Freightliner
Service Bulletin

Compressor Bracket Modification to Reduce Harness Chafing

54-330

Fig. 1, Area of Concern for Harness Chafing

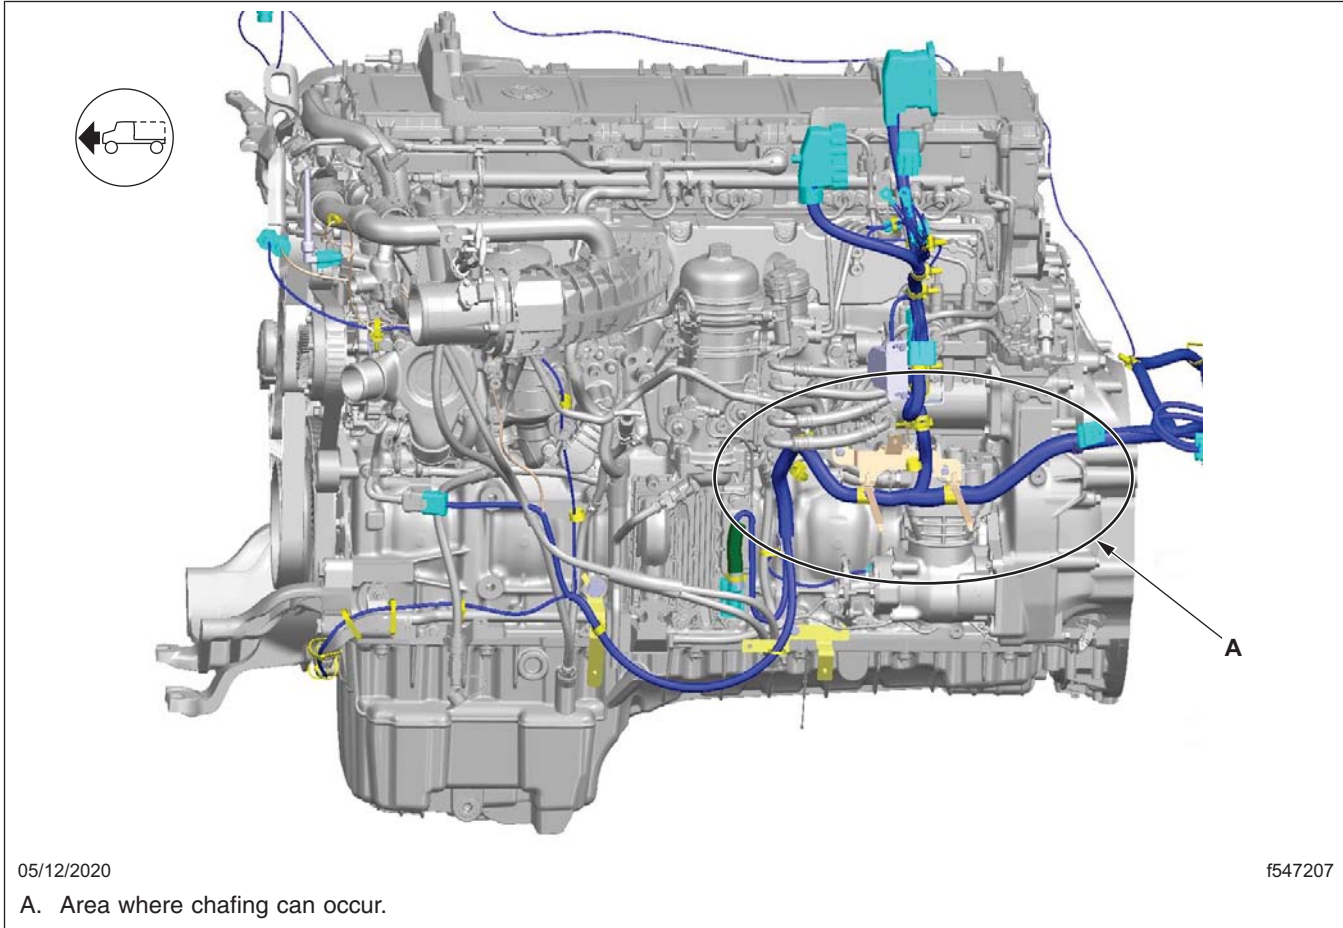
New Cascadia vehicles with Detroit HDEP engines may experience engine harness chafing at the harness support bracket that mounts on the air compressor. To avoid this issue, a new hole is drilled on the bracket to enhance the spacing with tie straps and reduce harness contact with the mounting bolt. Additional harness wrapping is added to reduce the harness chafing. The following are the possible symptoms that associate with this issue which may include one or more of these.

Fig. 3, New Hole Dimensions on the Bracket

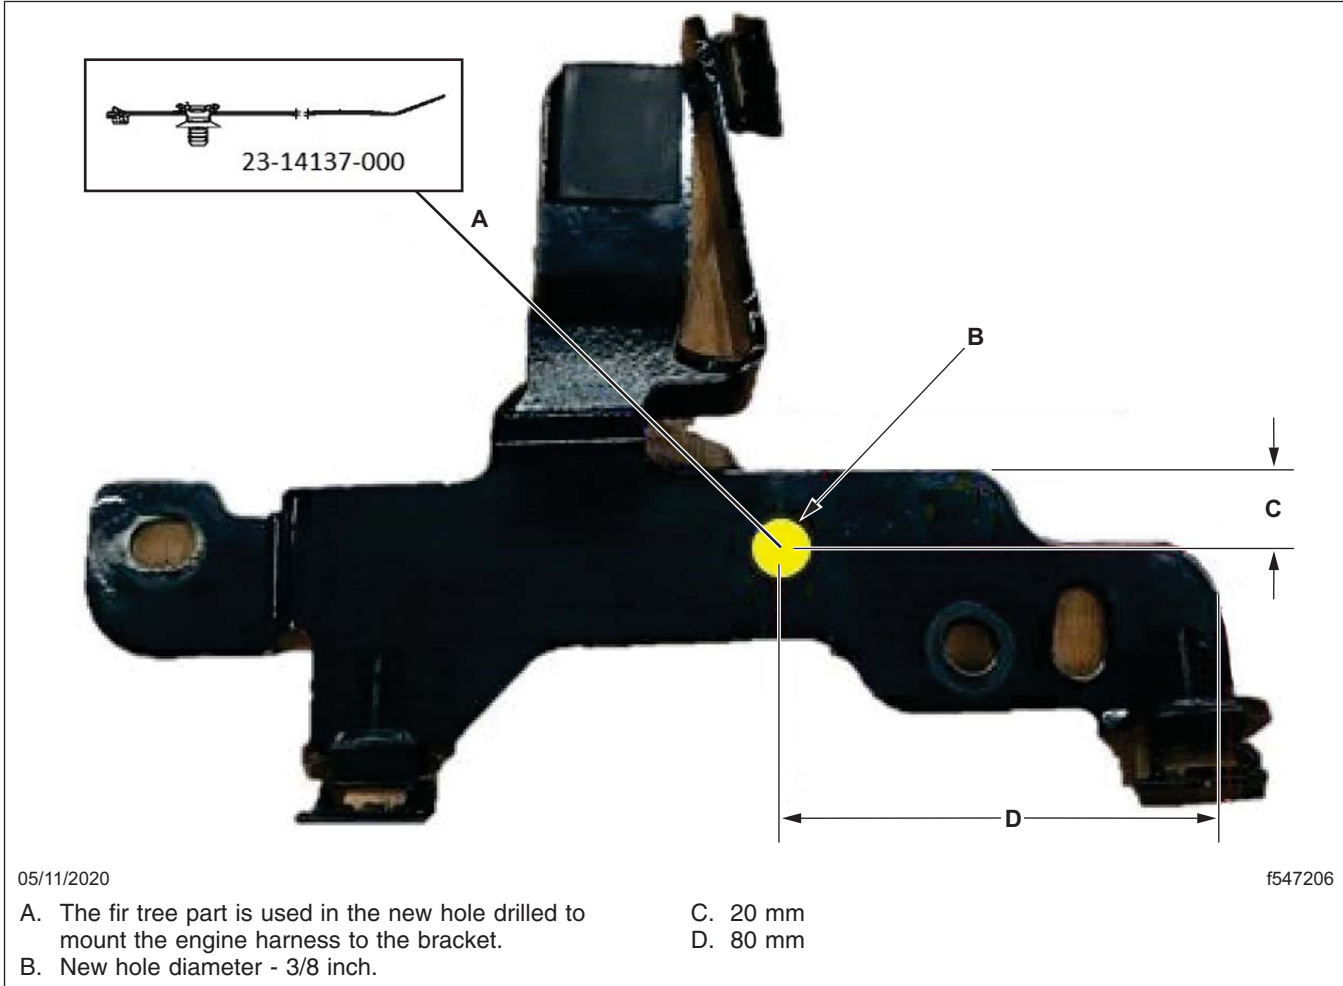
6. Using [Fig. 3](#) as a reference, drill a 3/8 inch hole in the bracket.

Fig. 5, Newly Drilled Bracket with Tie Strap

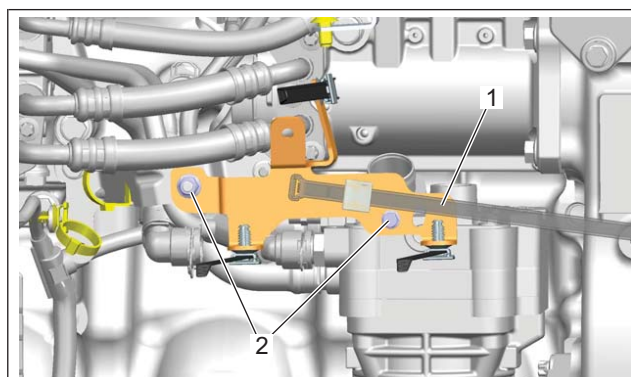
8. Install the newly drilled bracket with the fastener. Then, install a fir tree with tie strap (23-14137-000) into the new hole being used to fasten the harness to the bracket. See [Fig. 5](#).

Fig. 6, Securing the Harness to the Bracket

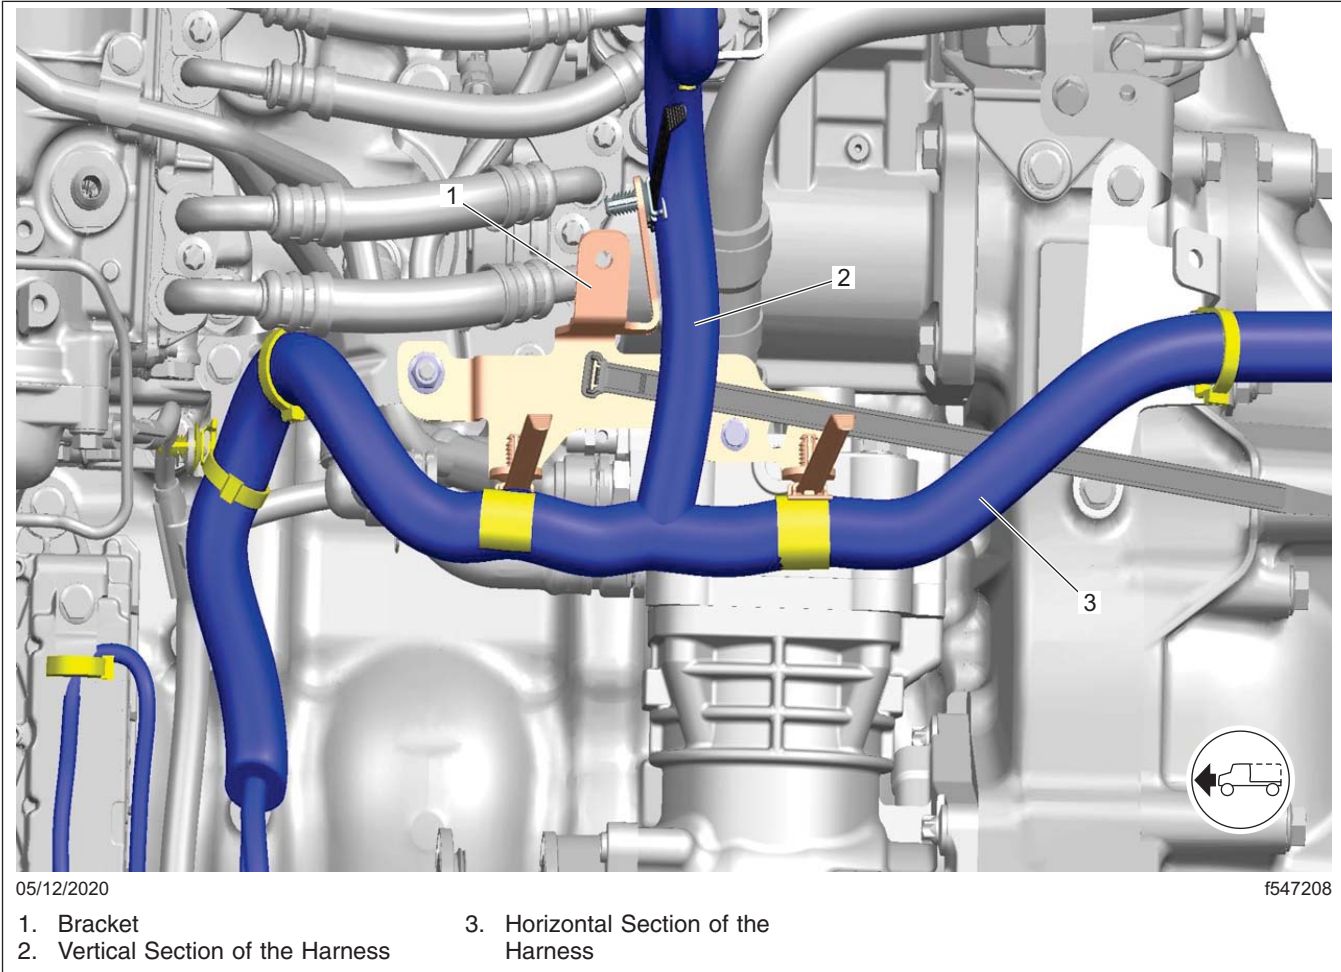
9. Secure the engine harness to the bracket using the fir tree and tie strap. See **Fig. 6**.
